NARRAGANSETT BAY COMMISSION

PHASE III COMBINED SEWER OVERFLOW PROGRAM
OF-210/213/214 FACILITIES

CONTRACT NO. 308.04C

60% DESIGN
JULY 2021

NARRAGANSETT BAY COMMISSION PHASE III COMBINED SEWER OVERFLOW PROGRAM	NBC CONTRACT NO 308.04C CIVIL	SHEET C-3
OF 210/213/214 FACILITIES PLAN AND PROFILE III: STA 4+00 - 8+00		195130227

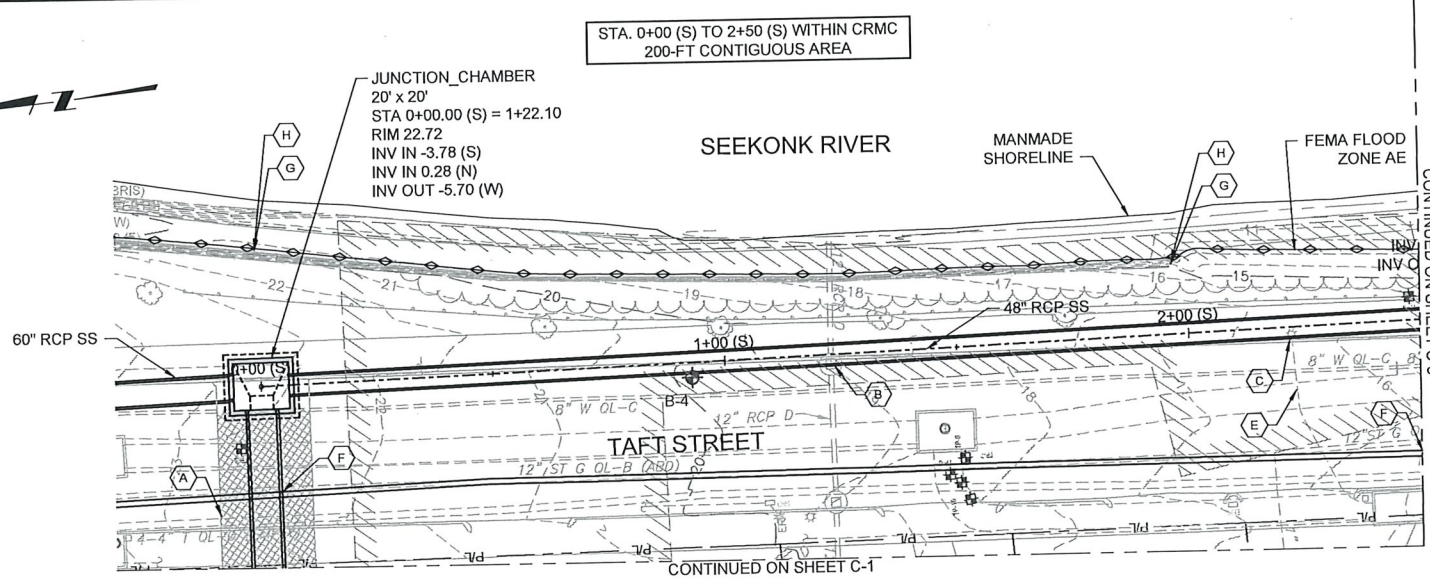
Format?
 Should these notes be reserved for B - Drawing?

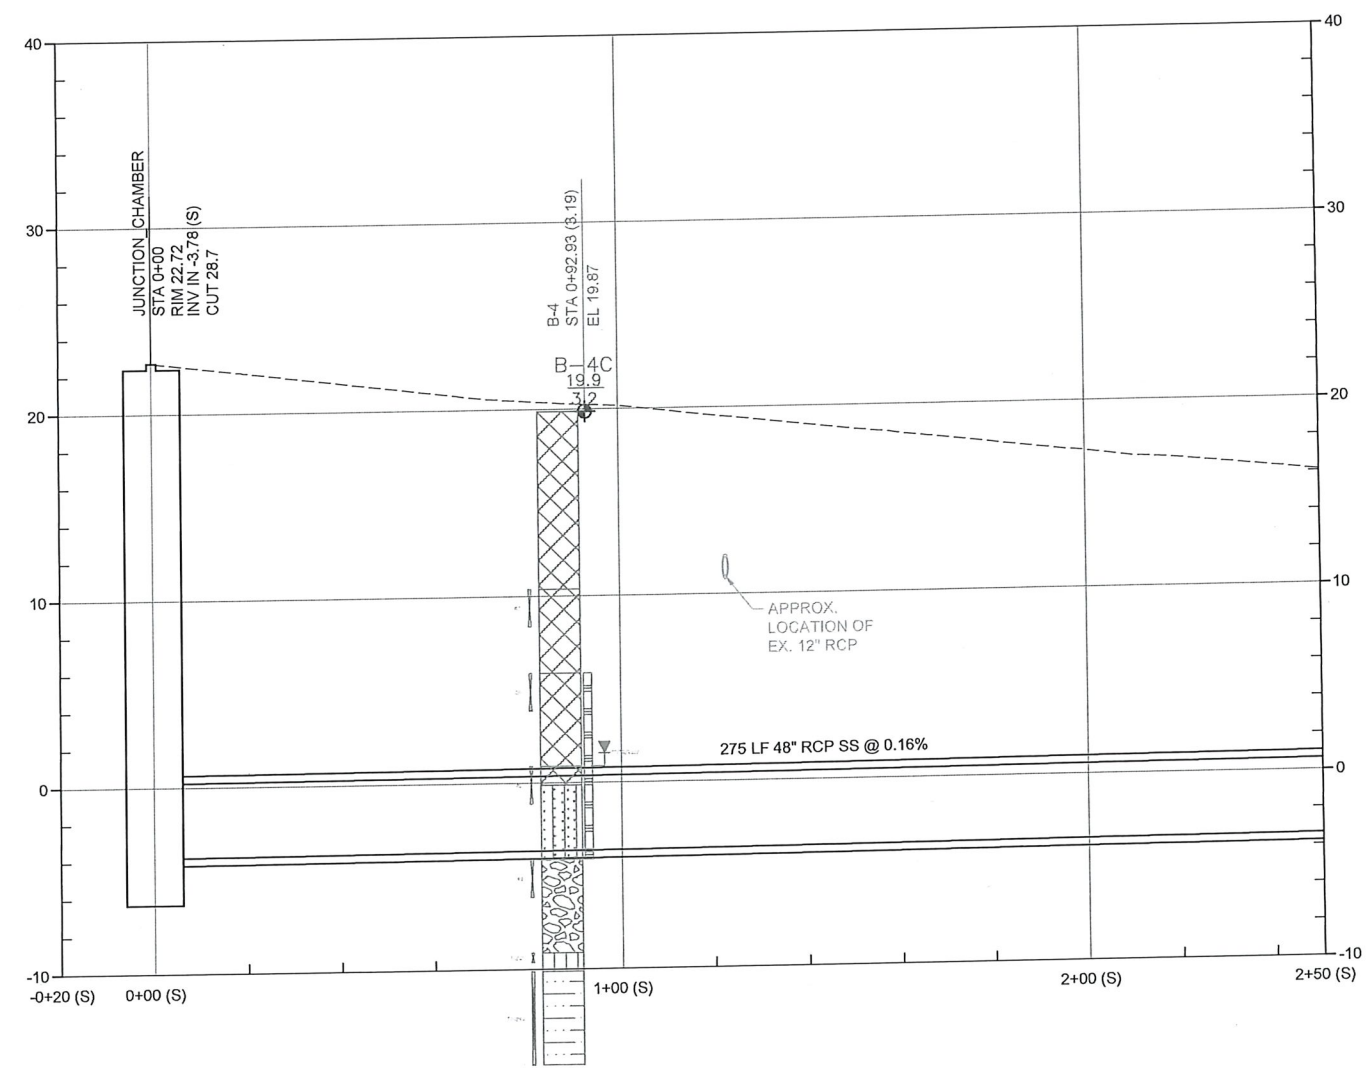
No "K"
 Please clarify -

NBC CONTRACT NO 308.04C
STRUCTURAL
OF 210/213/214 FACILITIES
JUNCTION CHAMBER REINFORCEMENT

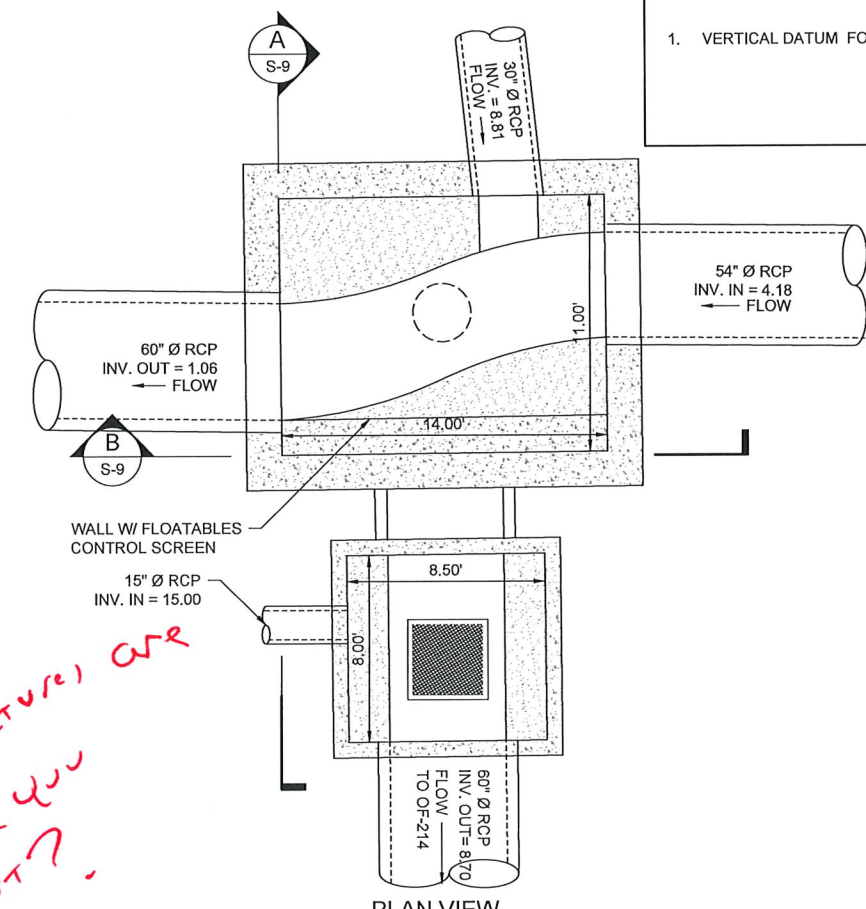
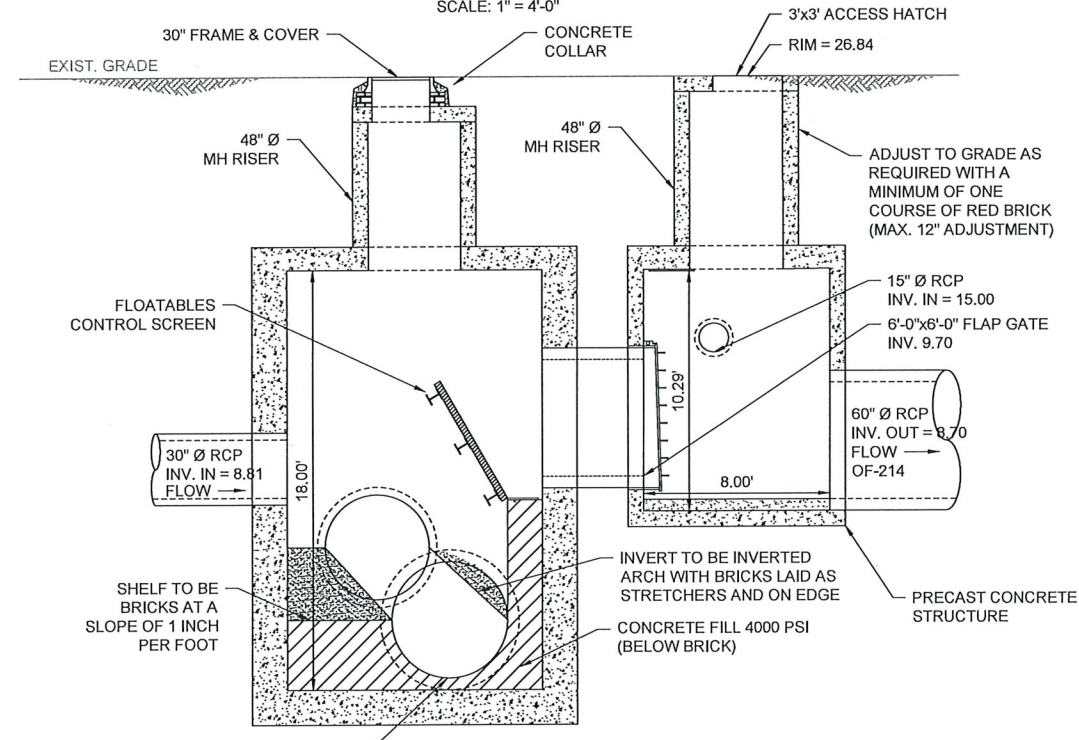
Dimensions of structures are NOT shown? Are you thinking pre-cast?

SHEET
M-1
195130227

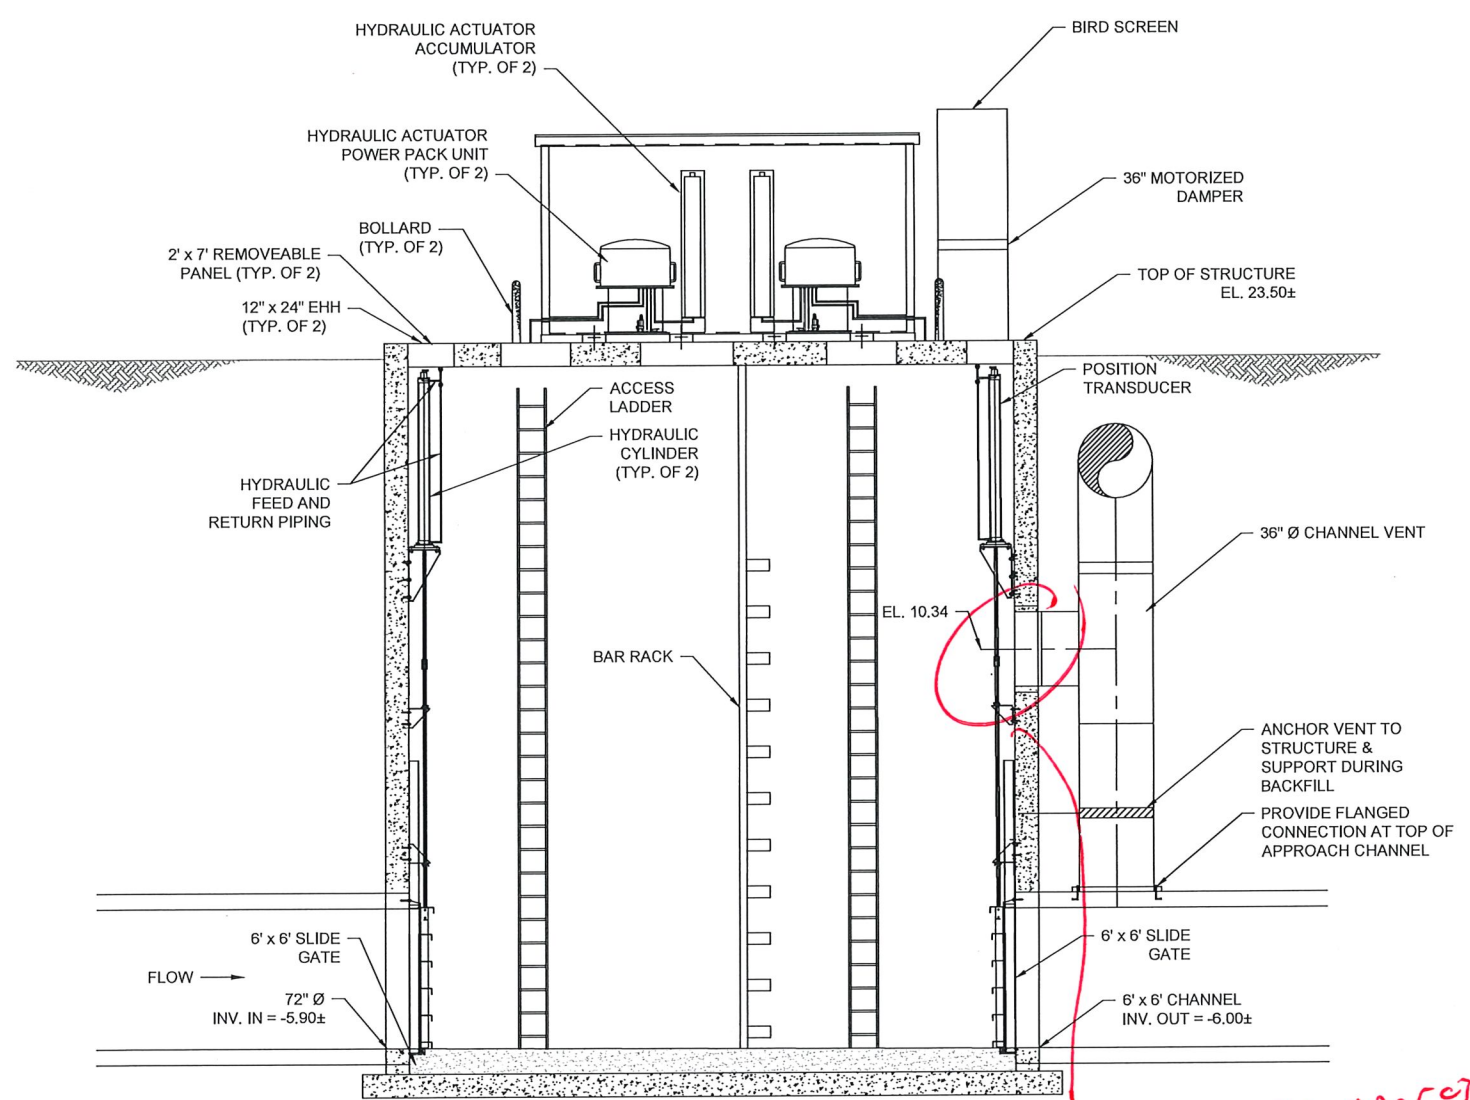
Will gate operation impact vent?
